# Access Compliance Report

## Public Rights-of-Way

### (Curb Ramps)

Intersection ID: 23907	Main Street: MCALPINE_FARM_RD	Cross Street: RIVER_RIDGE_RD	Location: SW
ADA ID: BFFF4C41A2FD	Ramp Type: PerpDiag	Initial Pass/Fail: Fail	Overall Compliance: No
Severity Score: 12.5			
Codes/Mitigation Info/Possible Solution		Field Measurements/Component Compliance

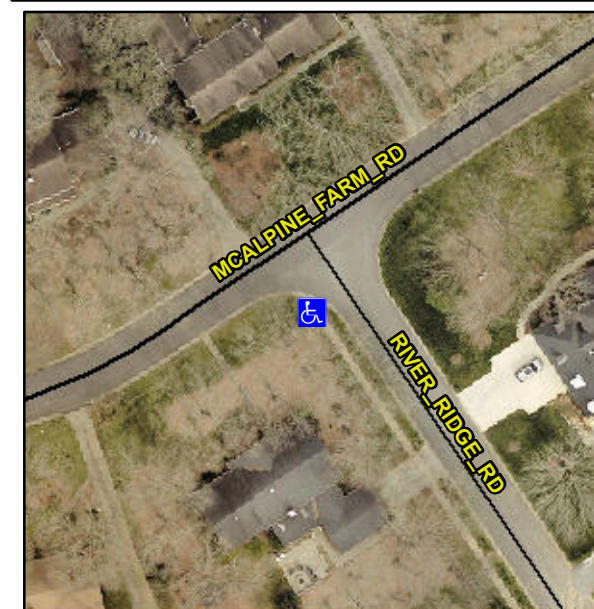
**Not Found, R304.5.3**

Compliance	Description	Data	Compliance	Description	Data
N/A	Ramp Length (in)	35.0	Yes	Ramp Slope (%)	8.3
Yes	Ramp Width (in)	48.0	No	Ramp XSlope (%)	6.2
N/A	Flare Type LT	N/A	N/A	Flare Type RT	N/A
N/A	Flare Slope LT (%)	N/A	N/A	Flare Slope RT (%)	N/A
N/A	Flare Traversable LT?	N/A	N/A	Flare Traversable RT?	N/A
N/A	Landing Length (in)	N/A	N/A	DWS Provided?	N/A
N/A	Landing Width (in)	N/A	N/A	DWS Contrast?	N/A
N/A	Landing Slope (%)	N/A	N/A	DWS Length (in)	N/A
N/A	Landing X Slope (%)	N/A	N/A	DWS Full Width?	N/A
N/A	Landing Curb? (Y/N)	N/A	N/A	DWS Offset (in)	N/A
N/A	Shared Landing?	N/A			
N/A	Gutter Ponding?	N/A	N/A	Gutter Slope (%)	N/A
N/A	Gutter Lip Ht (in)	N/A	N/A	Gutter X Slope (%)	N/A
N/A	Painted X Walk1?	No	N/A	Painted X Walk2?	No
	X Walk 1 Direction	To NE		X Walk 2 Direction	To NW
N/A	X Walk 1 Width (in)	N/A	N/A	X Walk 2 Width (in)	N/A
	X Walk 1 Slope (%)	2.6		X Walk 2 Slope (%)	3.3
	X Walk 1 X Slope (%)	4.0		X Walk 2 X Slope (%)	3.6

**Remove & Replace Curb Ramp With Two New Directional Ramps or Equivalent.**
